EXHIBIT LIST

Reference No: HOL/10018

Petitioner: EUSTON STANDARD PACK

The implications of HS2 Euston Action Group's proposal to locate the main HS2 London terminus at Old Oak Common

EE 2026 track layout

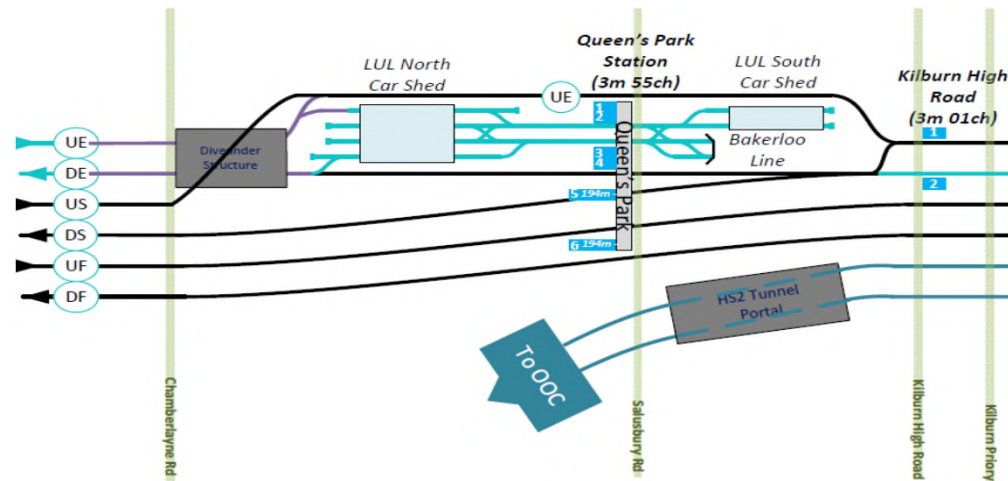
- A tunnel from Old Oak Common to a portal at Queens Park
- New track layout around Queens Park Station so as to merge the slow and DC (Direct Current) lines to release fast lines for HS2
- Rebore the South Hampstead DC line tunnels for container trains
- Merge the fast and slow lines into one pair of tracks between Camden Junction and the Camden Carriage sidings
- No 'GC gauge' clearance, so all HS2 trains would have to be 'classic compatible'
- Reinstate lost WCML capacity and provide GC gauge clearance in late 2030s onwards

Queens Park portal and dive-under locations

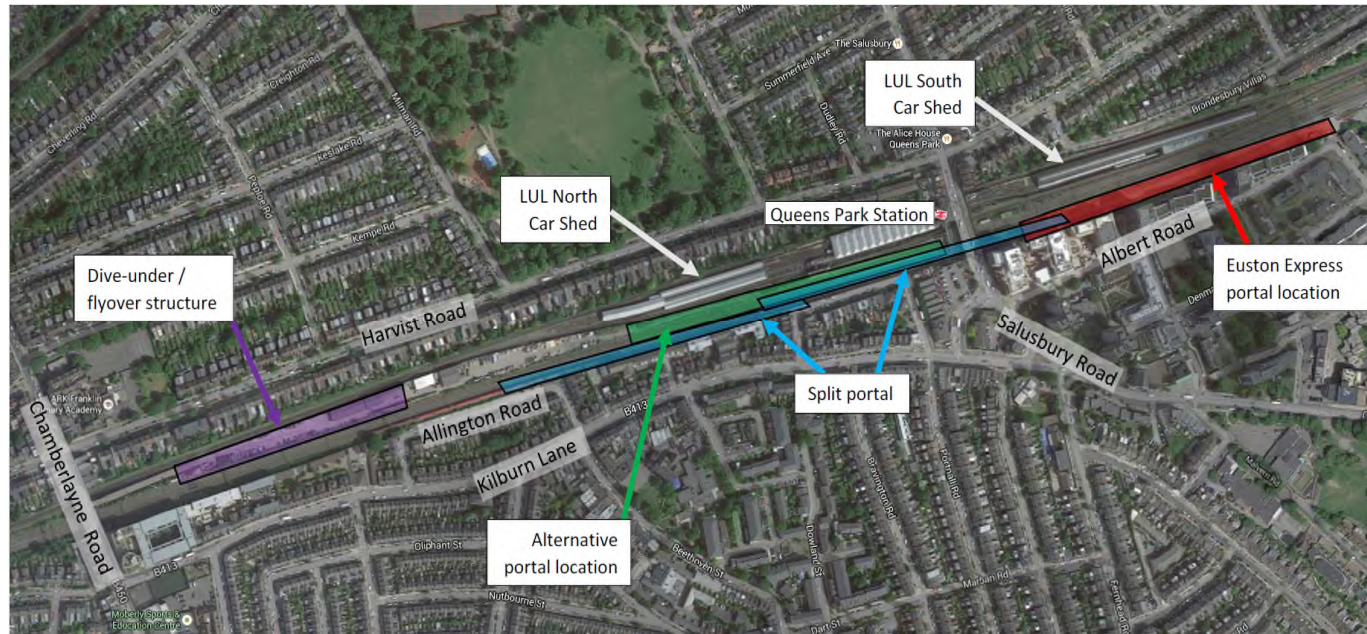
- EE proposed portal location east of station would require extensive residential demolition
- Promoter suggested location south of station
- EE now propose staggered portal (600m long, 10m wide)

EE track proposal at Camden Junction

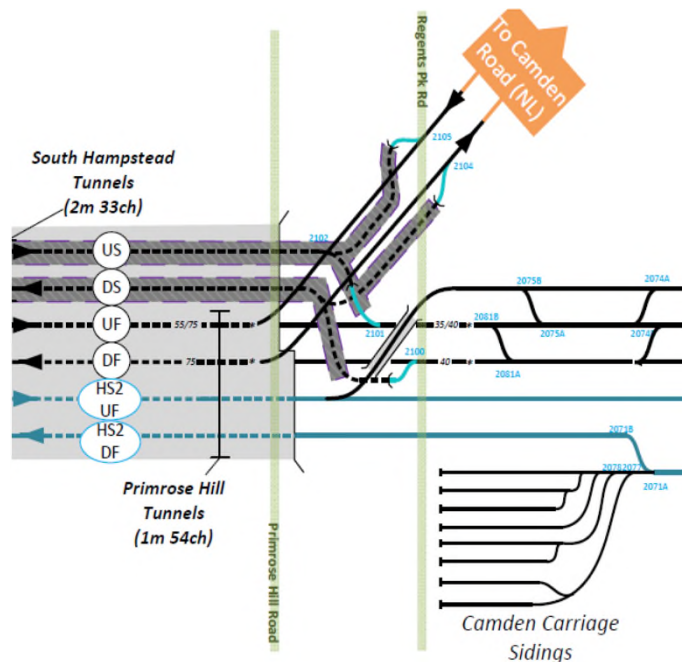
Reducing WCML to two tracks at Camden Junction would reduce WCML capacity into Euston by 25-35%

Insufficient platforms

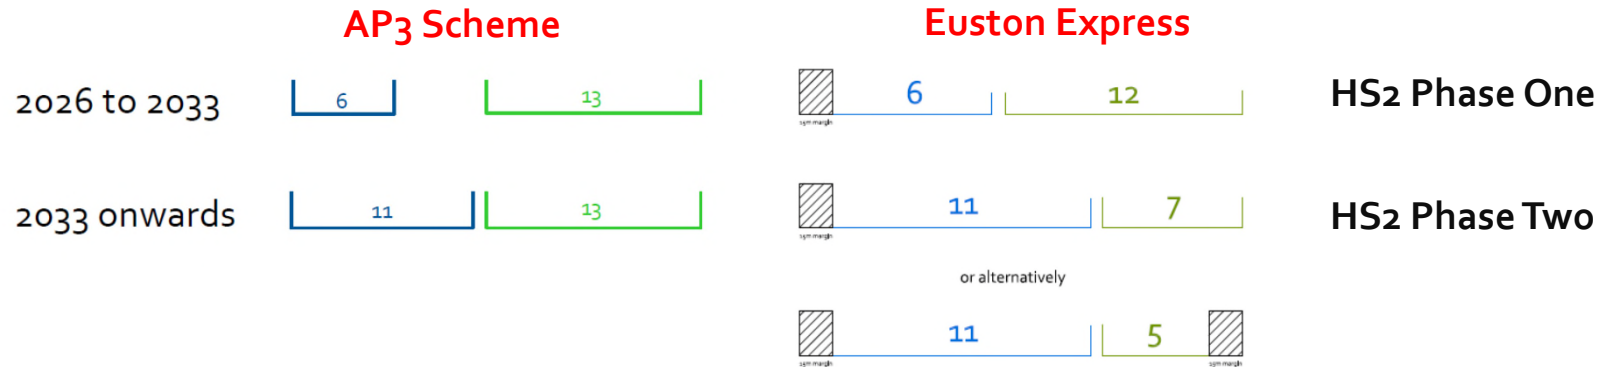
13 WCML platforms are needed after 2026

Between 2026 and 2033 the Euston Express proposal within the existing station footprint would leave space for only 12 WCML platforms

After 2033 there would be space for only 5-7 WCML platforms (depending on the extent of the edge zones)

HS2 within existing station footprint

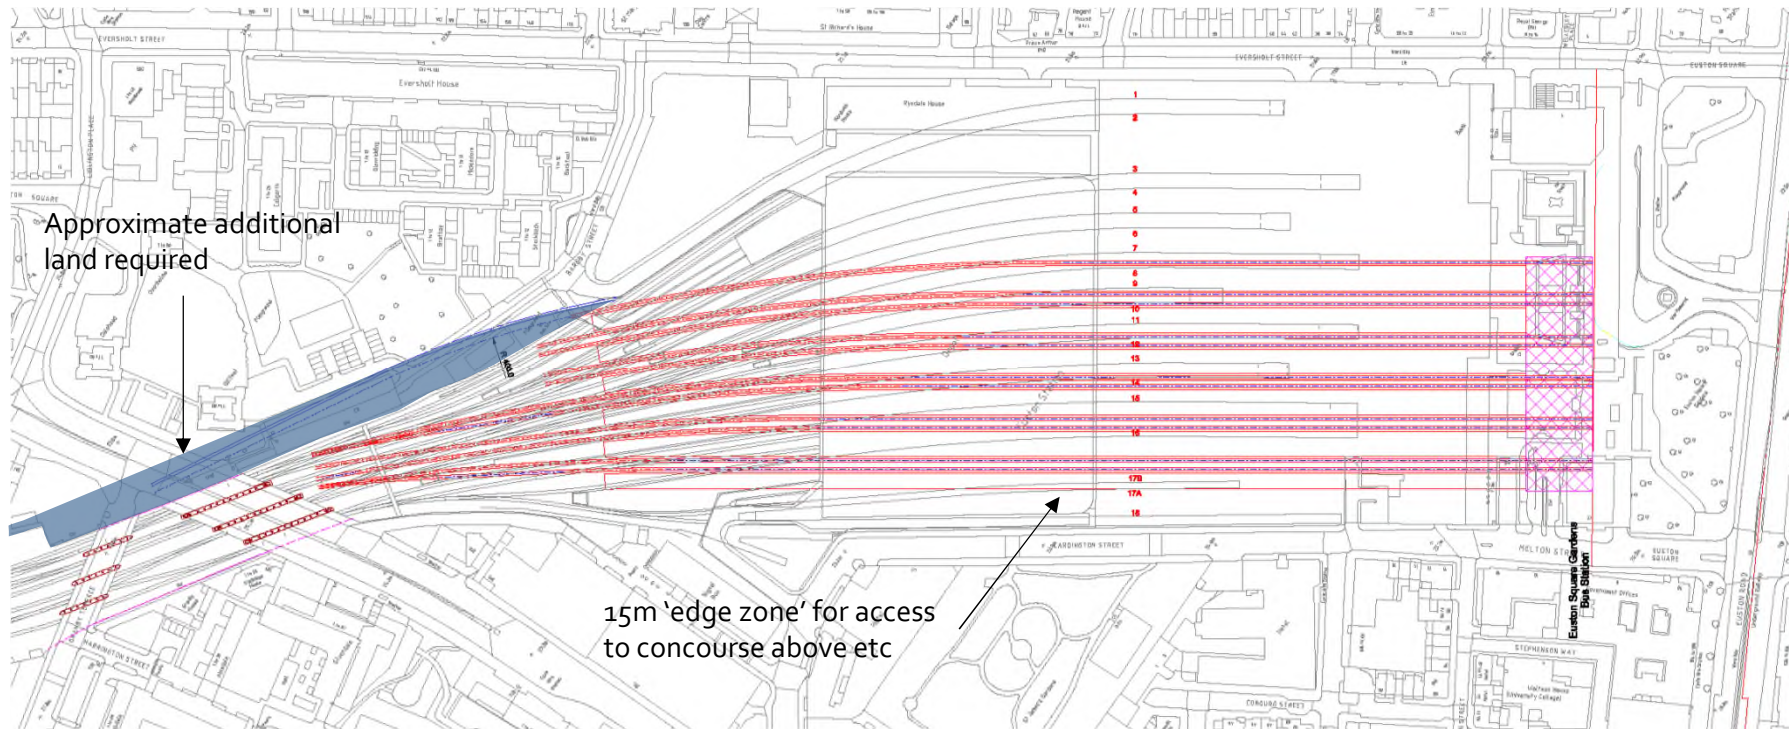
Without encroaching into Euston Square Gardens there is insufficient space under the existing Hampstead Road Bridge for the track fan at 400m radius

HS2 within existing station footprint

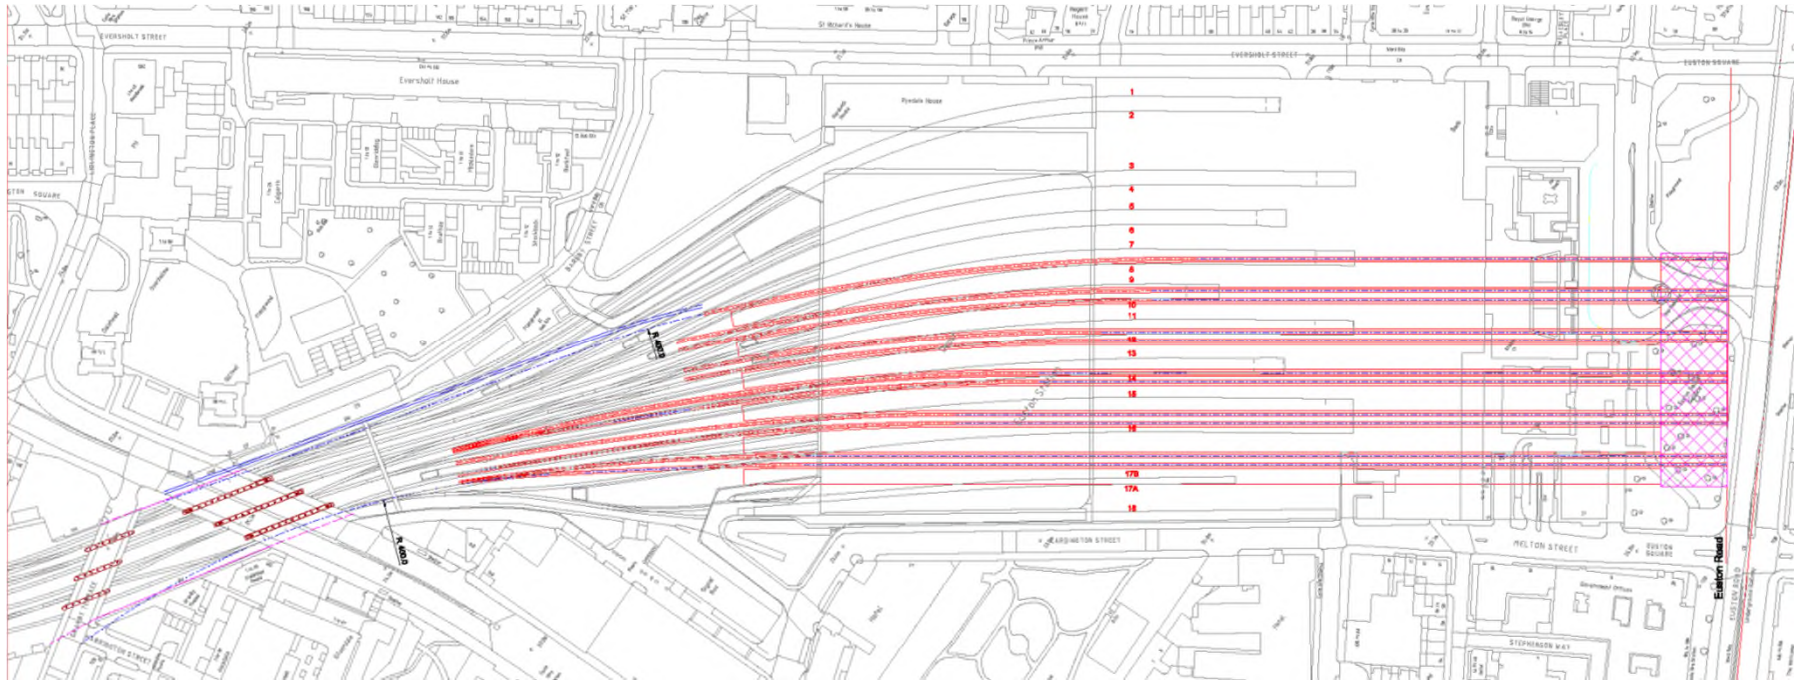
- If HS2 platforms were extended to Euston Road there would still be no space under Hampstead Road Bridge for WCML tracks at 400m radius

Figure 2 Track layout at Queens Park

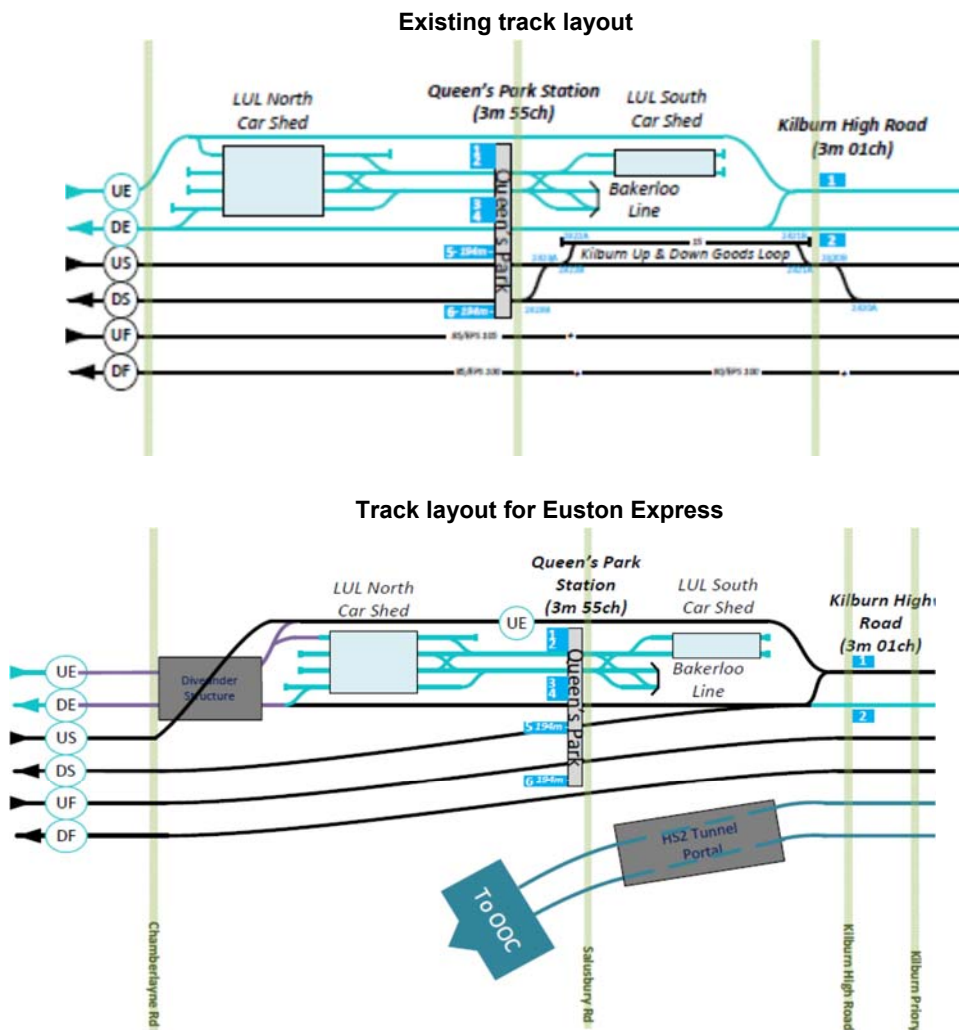
16. Figure 2 shows the track layout around Queens Park station where the Bakerloo Line diverges from the DC lines. The Bakerloo Line leaves the WCML just west of the London Underground North Car Shed and continues through the station and eastwards in tunnel, while the DC line tracks run north and south of the station and the LUL carriage sheds and on to Primrose Hill.

17. The EE proposal would release the fast line corridor on the south side of the WCML by slewing the existing fast lines onto the slow line tracks, and the slow lines would be connected into the DC lines. Figure 2 also shows EE’s proposed layout.

Figure 2 Slow/DC Line dive-under

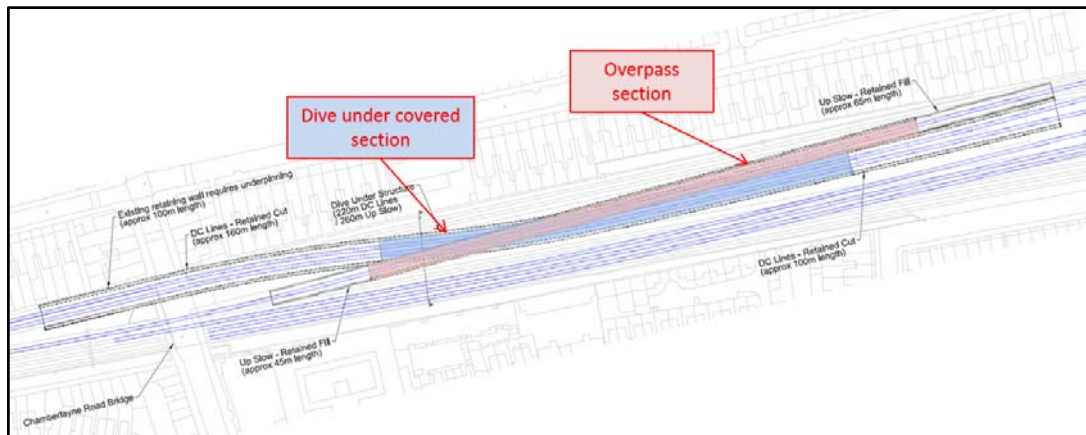
19. In order to build the fly-over/dive-under structure, even at maximum gradients the Up Slow line would need to be raised in the vicinity of Chamberlayne Road to ensure sufficient headroom clearance to the Down DC line. This would entail raising Chamberlayne Road bridge by approximately 2 metres. The civil engineering works for the fly-over/dive-under would extend over approximately 1 km in a location where existing housing abuts the railway on both sides of the WCML, and would take just over two years to complete. The works would also cause severe disruption to Bakerloo line services for approximately 12 months.

Figure 4: Portal and fly-over/dive-under locations

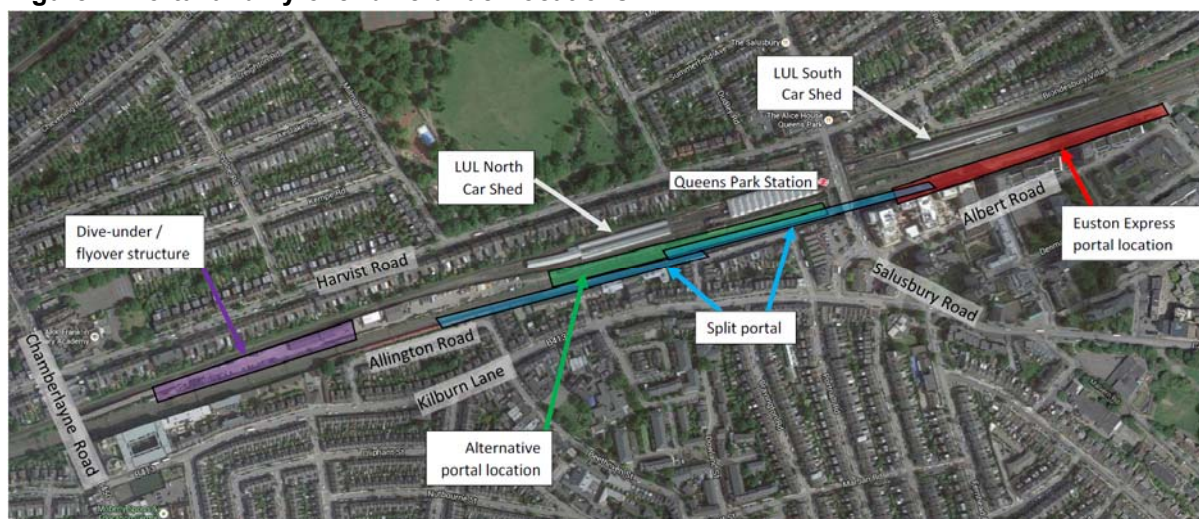
21. Two options for an HS2 portal south of Queens Park station were considered, only one of which would be feasible (See PB/Mott Section 6.4). The portal and ramp would be over 520m long and would need to be built in two stages. It would take approximately 2½ years to build. Compared with the Promoter’s Euston tunnel proposal, construction work for the EE proposals at Queens Park would add two years to the overall construction programme.

22. In *Re-visioning Euston* (p.24), the promoters of EE criticise this analysis and instead propose that the HS2 portal should be staggered to reduce the width of the land required. Though in principle this arrangement could be fitted more or less within the railway boundary, it would present other problems. The structures would extend over 600m with almost continuous residential property adjoining the railway on the south side. The location is shaded blue on Figure 4.

Figure 6 Euston Express track layout at Camden Junction

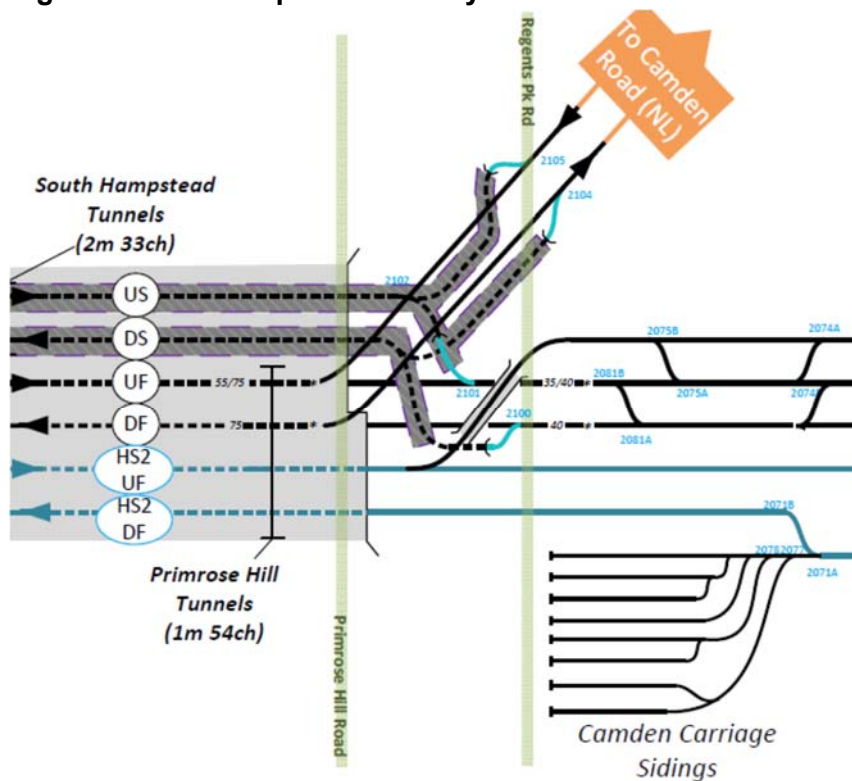
33. Between Camden Junction and Chalk Farm, the EE proposal would merge the DC/slow lines with the fast lines so that for a distance of approximately 400m all WCML passenger trains to and from Euston would share a single pair of tracks. (see Figure 6) In the busiest 60 minutes during the a.m. peak in the current WCML timetable, 27 passenger trains run over this section of track into Euston and 25tph in the busiest p.m. hour.

34. After implementation of HS2, the current working assumption is that up to 25 trains per hour would operate in and out of the classic platforms at Euston, as long distance trains are replaced by medium- and short-distance services. On the current planning rules requiring a 3-minute headway, only 20tph would be possible and that would assume no spare capacity to ensure reliability of train service operations. Though instances of shorter headways are cited in *Re-visioning Euston* (p.23), these are not comparable with the Euston approaches, for instance in relation to signal sighting.

Figure 8 Effect of building HS2 platforms within existing station

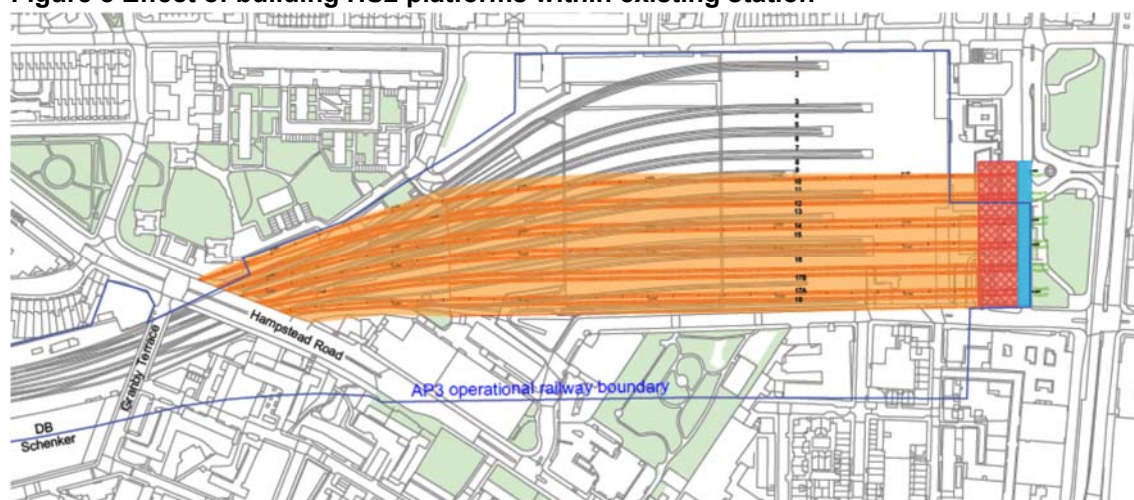
59. At Granby Terrace, the existing WCML tracks are 40m wide and fill the available space. The width of the railway at this point needs to be extended by a minimum of 35m for the HS2 tracks just south of the cross-overs, irrespective of the length, width or number of platforms at Euston. Figure 8 illustrates the effect on the WCML of building the HS2 tracks within existing railway land at Hampstead Road Bridge.

60. By Hampstead Road bridge the minimum width required for HS2 has increased to 75m as the tracks start to fan out into the platforms. At this point the land required for the HS2 tracks could not be reduced by much even if the HS2 platforms could be fitted into the existing station footprint and extended southwards. Hampstead Road Bridge would still need to be rebuilt and almost all the blocks of flats on the Regents Park Estate that would be acquired for the Proposed Scheme would also be needed for the EE proposal.

Double deck on east side of the station

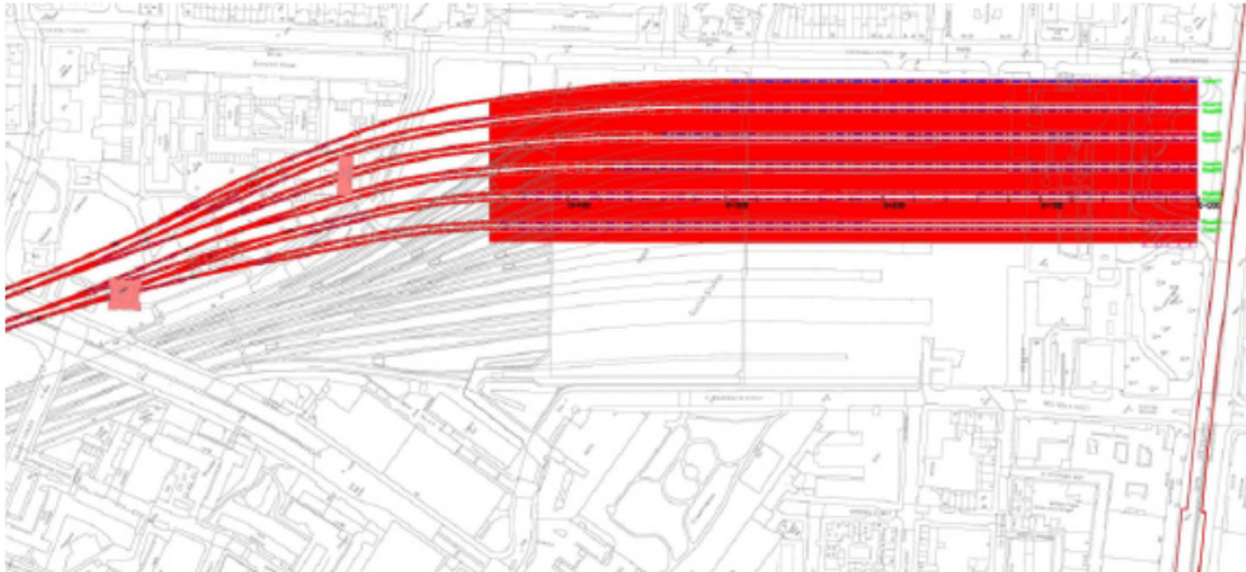
- Double deck on east side would entail extensive demolition in Ampt Hill Estate and Mornington Crescent
- Only half the WCML platforms available during construction

Double deck on west side of the station

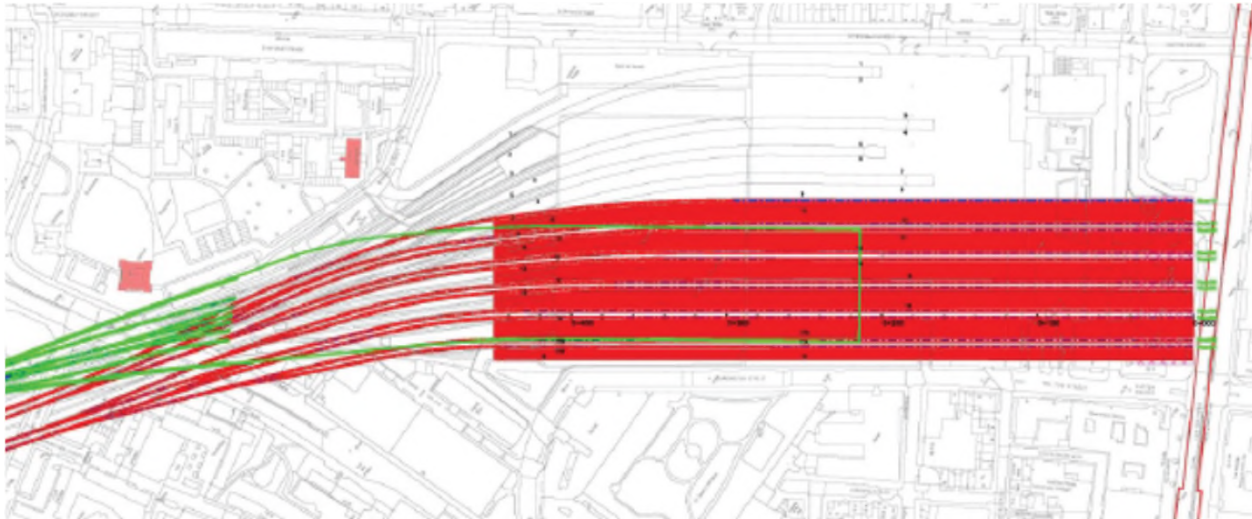
- Double deck on west side would still require most of the property acquisition north of Cardington St
- Only half the WCML platforms available during construction unless station built partly on land between Melton St and Cobourg St
